TRANSMITTAL OF DELIVERABLE FOR MILESTONE M-45-05J-T01 COMPLETE TANK
241-C-106 DESIGN

C-106 Waste Retrieval and Closure Demonstration Project Design Briefing

1a. ECN 720391 R 0

7. Title Modify C-106 Waste Retrieval P&ID			8. Bldg. / Facility No. 241-C, 241-AN		9. Equipment / Component ID 241-C-103, 241-C-106, 241-AN-106		10. Approval Designator ESQ

Document/Drawing No. H-14-105666 Sheet 1 Revision 2
(Note: A separate ECN Continuation page shall be used for each document/drawing to be modified.)

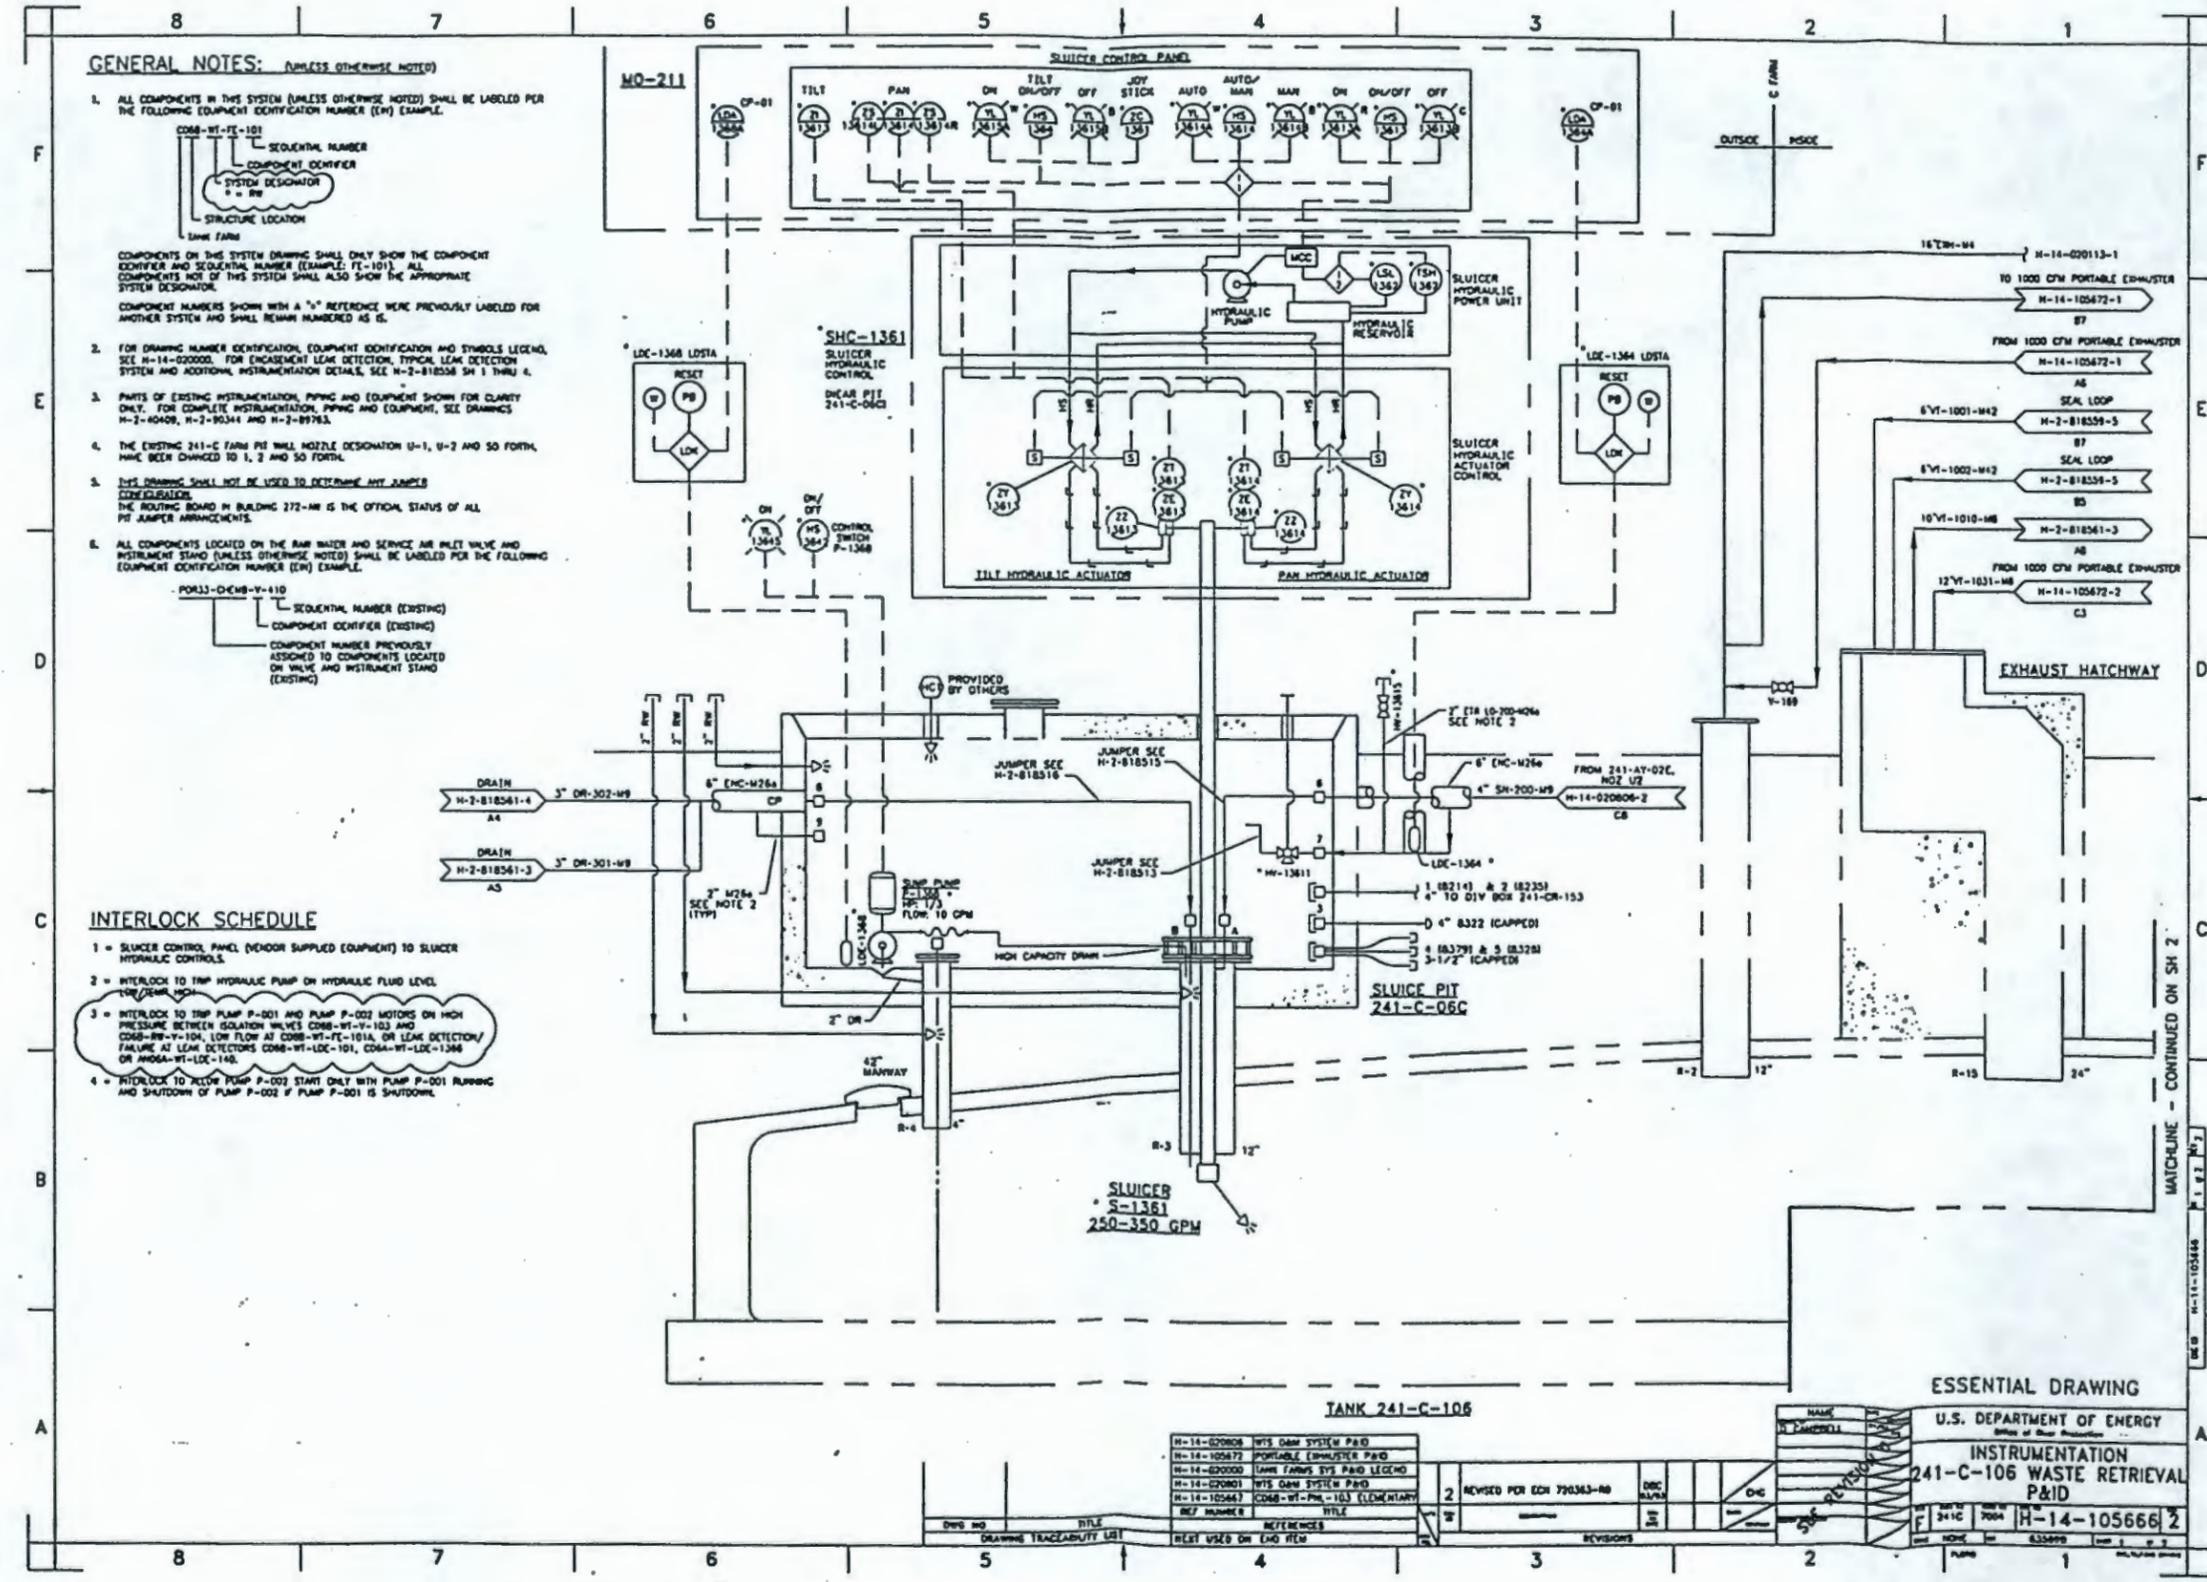
NO.	DATE	DESCRIPTION	BY	CHKD
1		REVISED FOR ECN 720391-R0	DM	DM
2		REVISED FOR ECN 720391-R0	DM	DM

Document/Drawing No. H-14-105666 Sheet 2 Revision 2
 (Note: A separate ECN Continuation page shall be used for each document/drawing to be modified.)

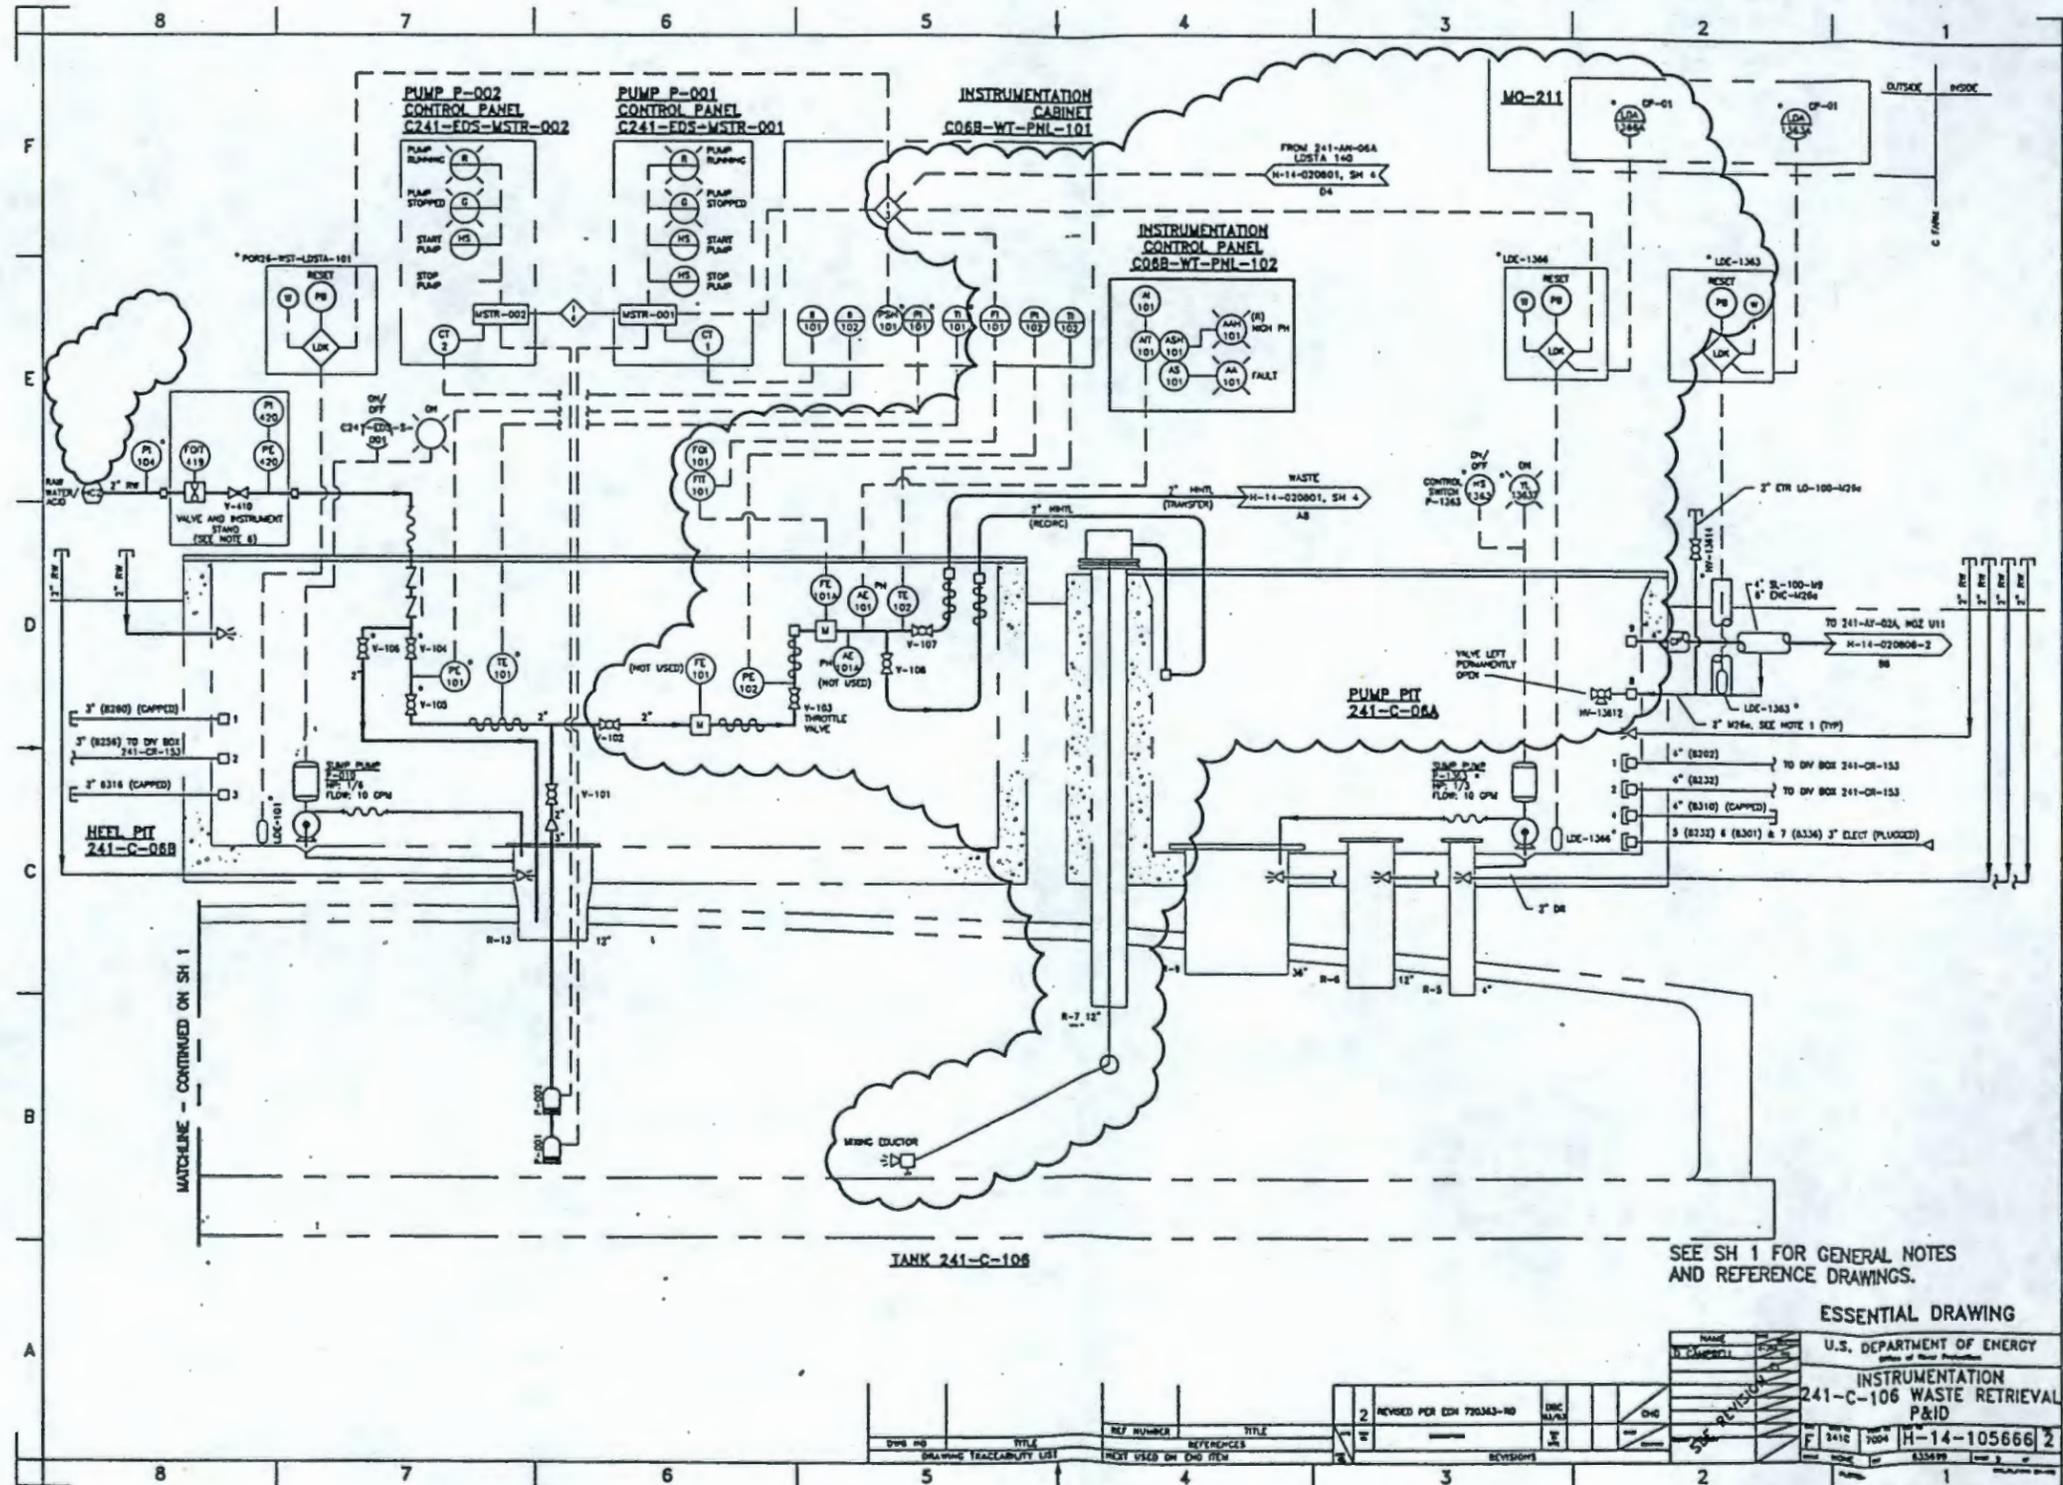
REV	NO.	DATE	DESCRIPTION
2			REVISED PER ECN 720343-10
1			ISSUED FOR CONSTRUCTION

Document/Drawing No. H-14-020801 Sheet 4 Revision 34 12
 (Note: A separate ECN Continuation page shall be used for each document/drawing to be modified.) 4/30/03

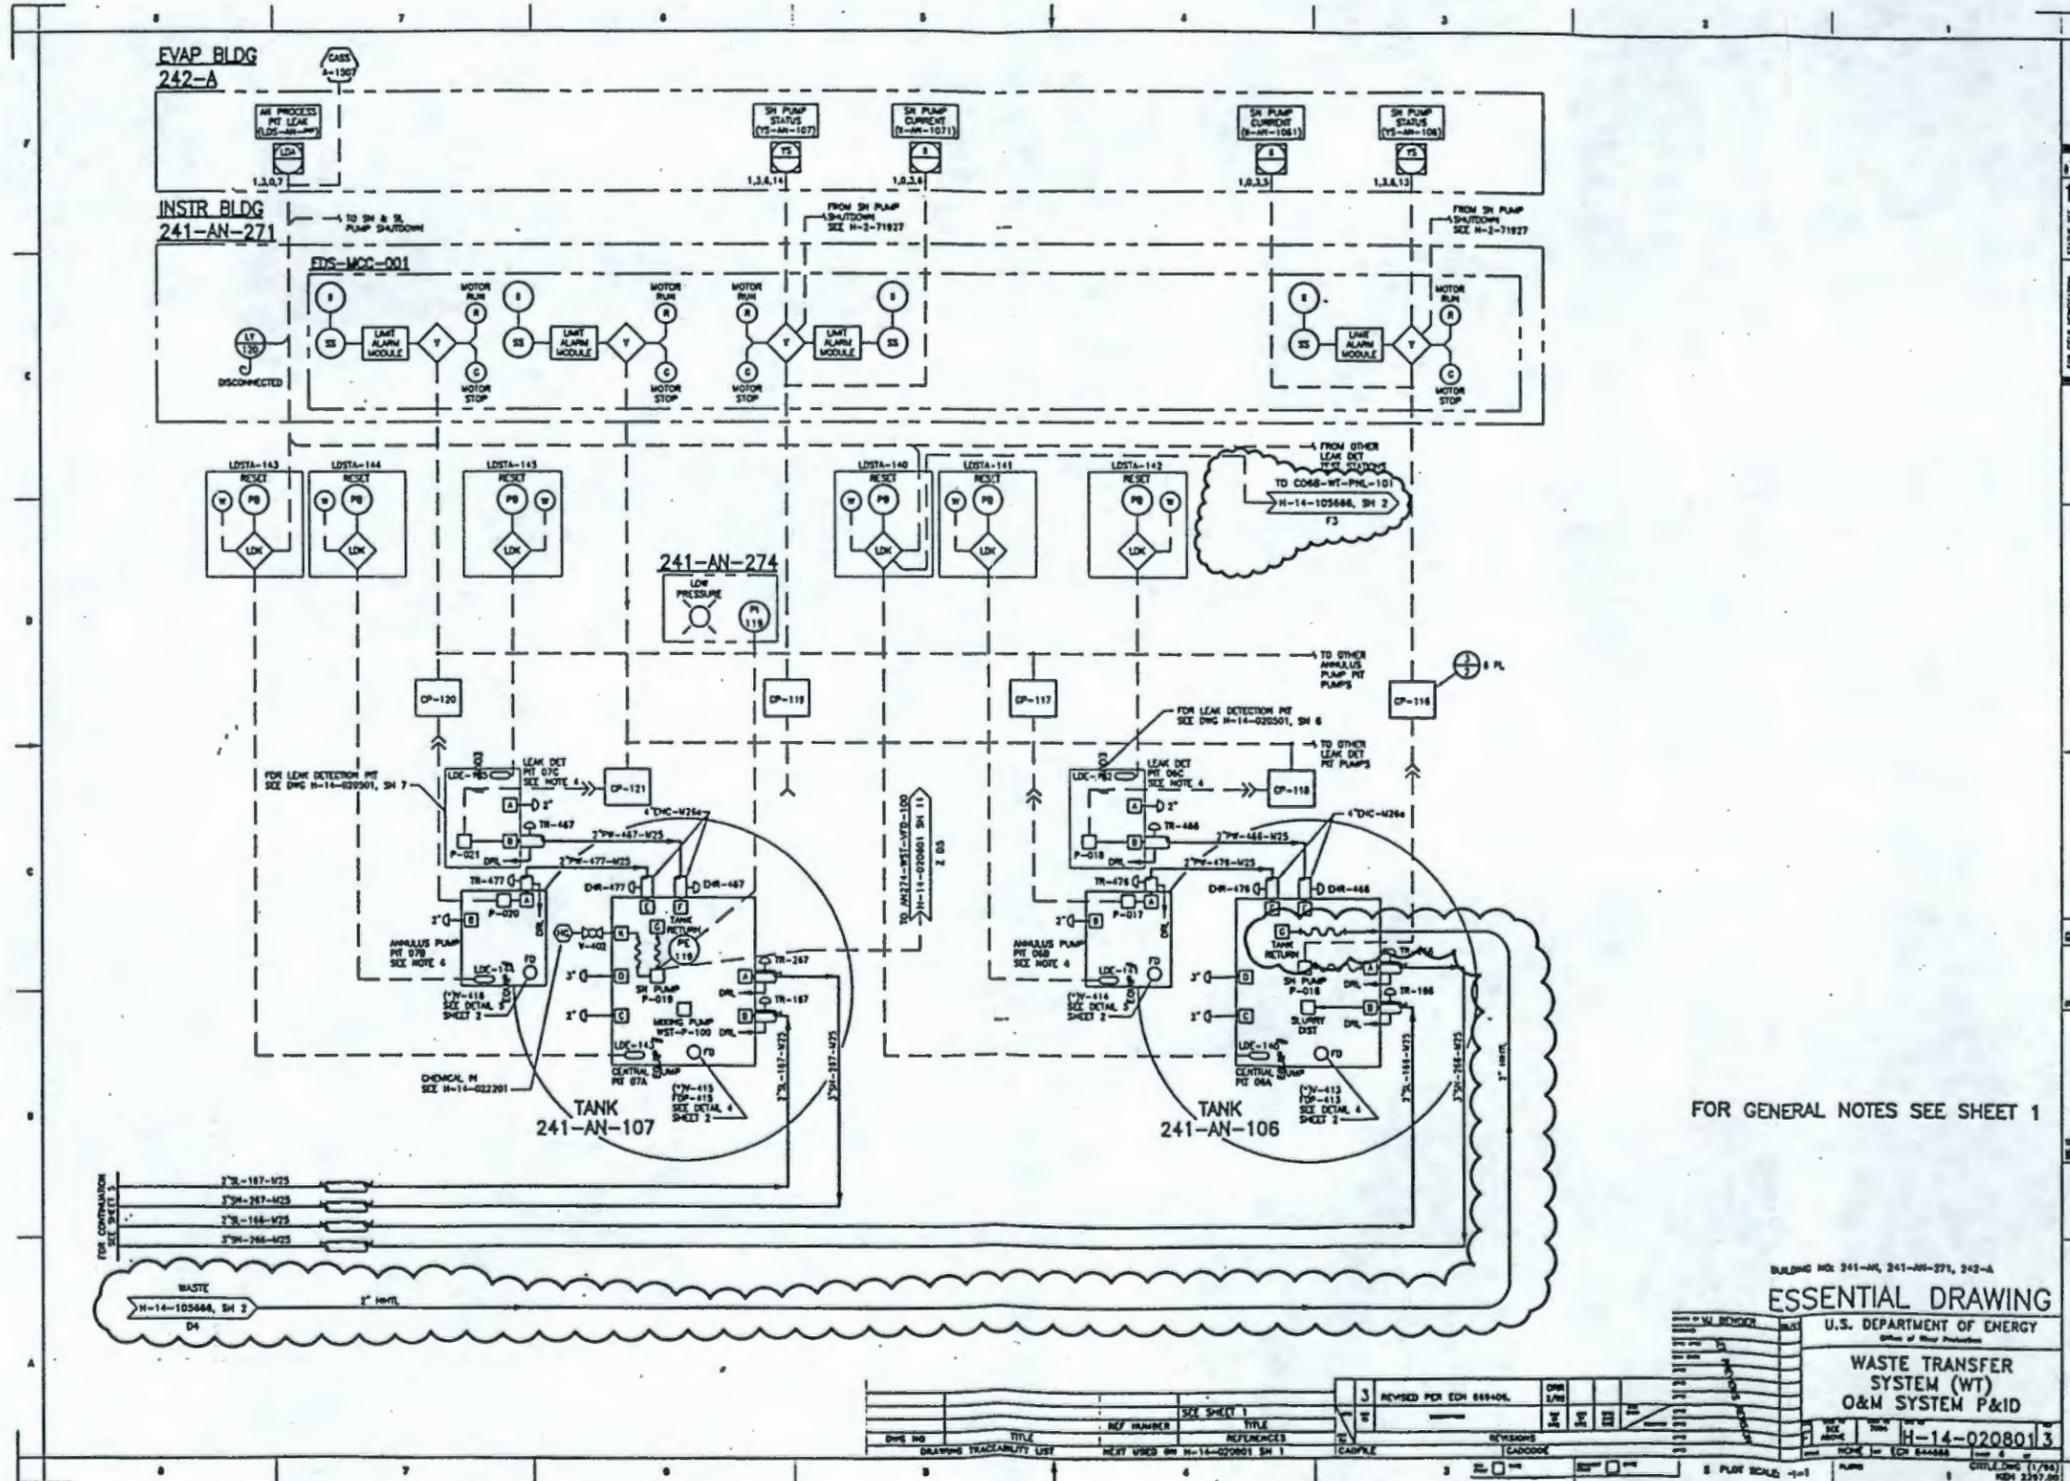
REV	NO	DATE	DESCRIPTION	BY	CHKD
3			REVISED PER ECH 88840L		
2					
1
